The amendments revise the TSs to reflect fuel reloading for Catawba Unit 1's
Cycle 6 operation with fuel manufactured by the B&W Fuel Company and to continue
to reflect the previously existing TSs for Unit 2 fuel.

SUBJECT: ISSUANCE OF AMENDMENT NO. 86 TO FACILITY OPERATING LICENSE NPF-35
AND AMENDMENT NO. 80 TO FACILITY OPERATING LICENSE NPF-52 - CATAWBA
NUCLEAR STATION, UNITS 1 AND 2 (TACS 79419/79420)

Amendment No. 86
License No. NPF-35

Amendment No. 80
License No. NPF-52

FIGURE 2.1-1a

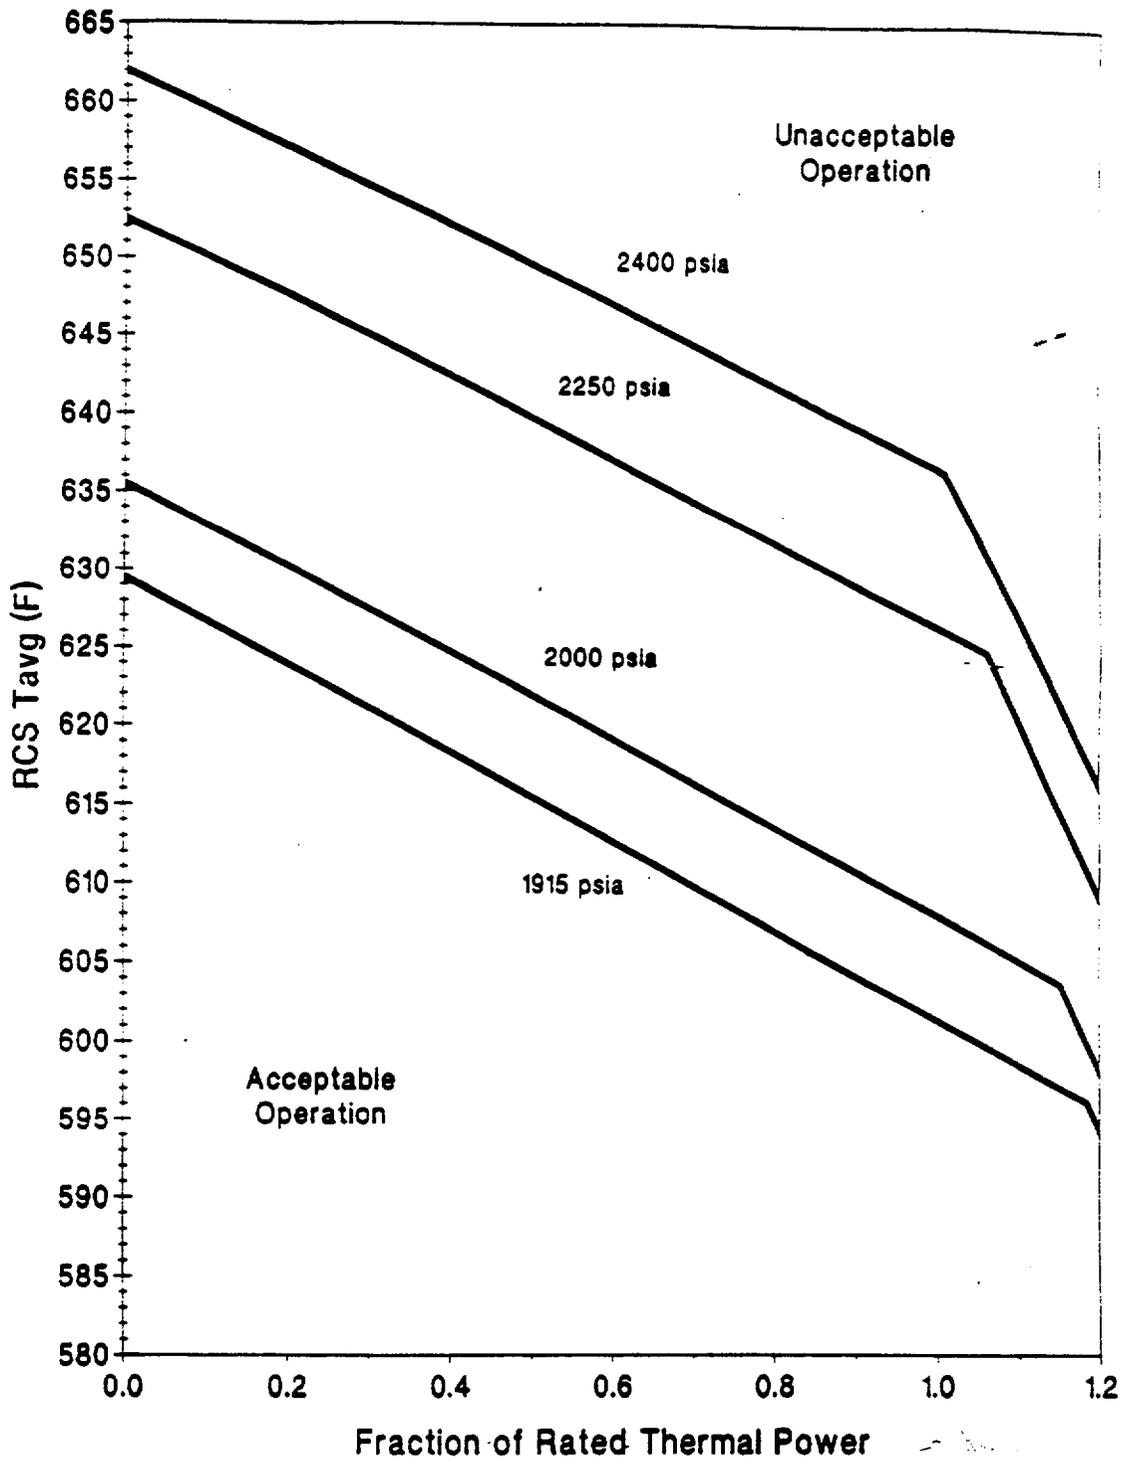
- (1) Index, pages III, IV, V, VIII, XIII; administrative changes adding titles and page numbers for new material. This is acceptable.
- (2) TS 2.1 Safety Limits; a new Figure 2.1-1 is added for CNS1 for the reactor core safety limits because of the new BWFC safety analysis methodology. The current figure is retained for CNS2. This is acceptable.
- (3) Table 2.2-1 Trip Setpoints; there are small changes to the Loop Minimum Flow, Neutron Flux High and Coolant Flow Low Setpoint (both conservative) and various TA, Z and Sensor Error values. These are based on values used in the safety analyses and a reexamination of plant-specific uncertainty values. They apply in general to both units. Values of constants in the Unit 1 OP delta T and OT delta T trip functions were

Figure 3.2-1 Reactor Coolant System Total Flow Rate Versus Rated Thermal Power - Four Loops in Operation (Unit 1)

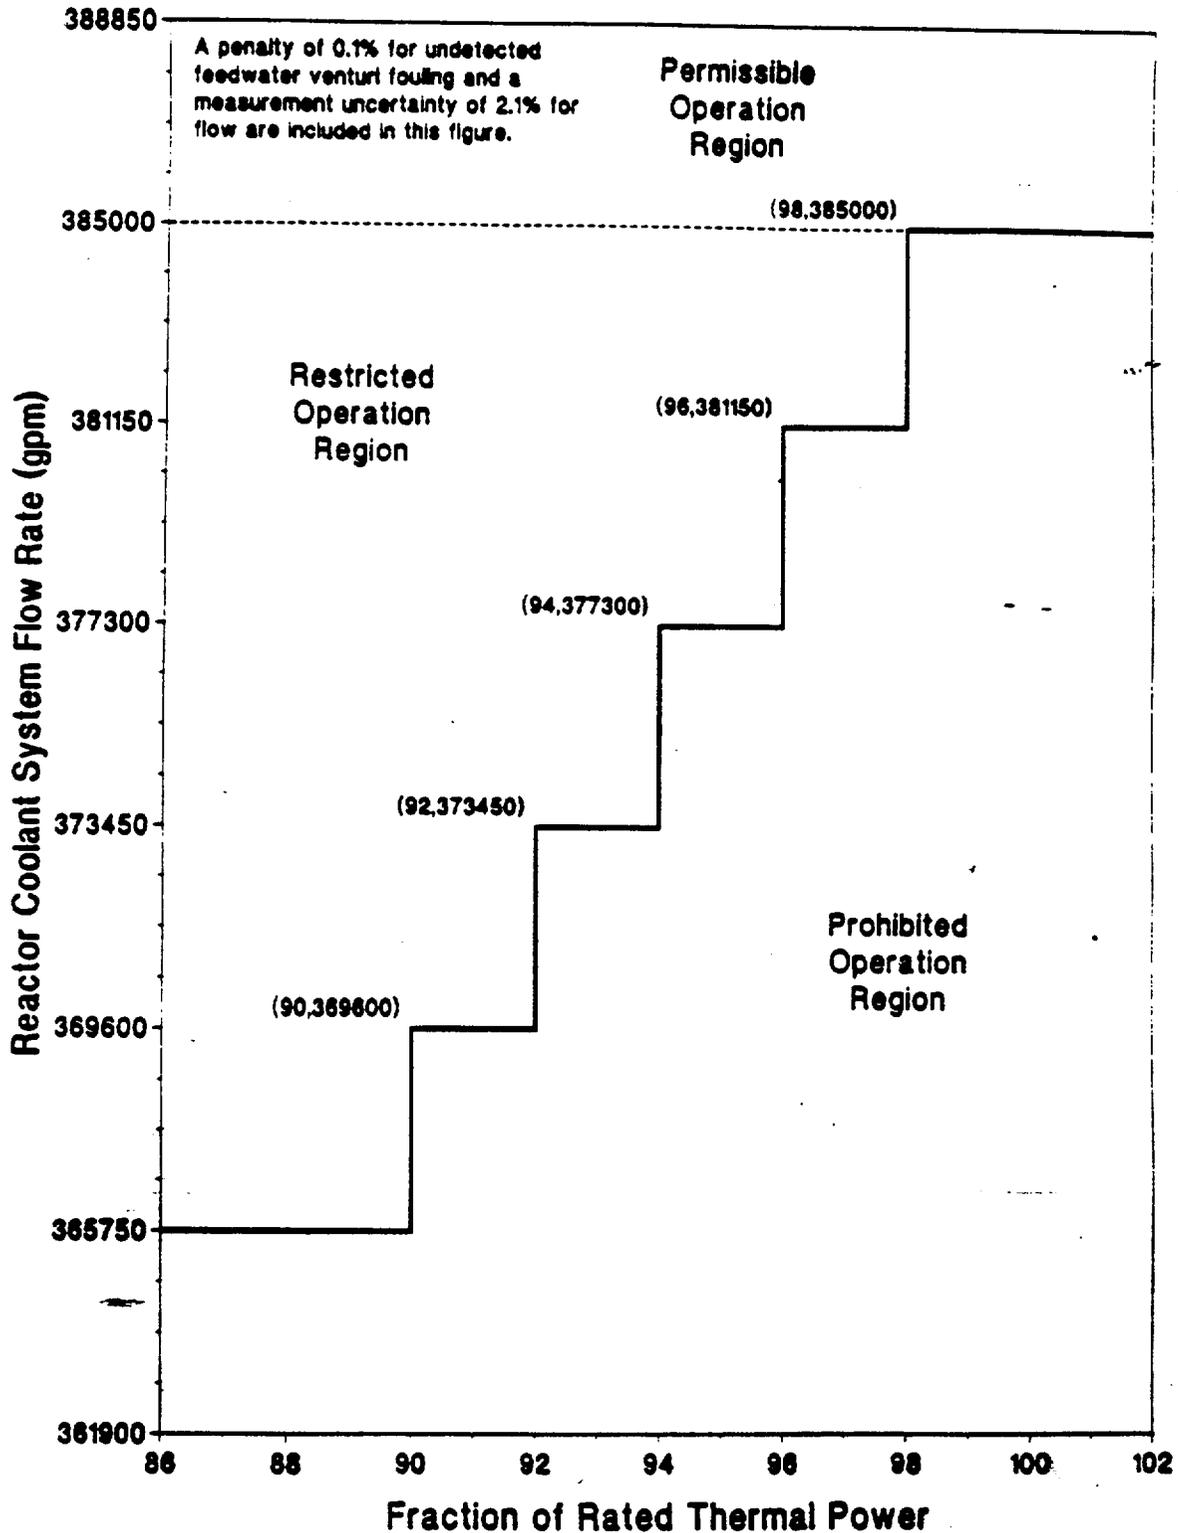
- (8) TS 3/4.2.5, DNB Parameters; the reactor coolant flow rate limit is moved from TS 3.2.3 to this TS, and is incorporated in a new Figure 3.2-1, where it is combined with the power level to provide permitted, restricted or prohibited operating regions. This figure defines trade-offs in power and flow and has been verified by a number of thermal evaluations. It provides comparable margins to those provided in the previous Westinghouse design TS 3.2.3, which is now revised. It is acceptable. The changes apply to Unit 1 only.
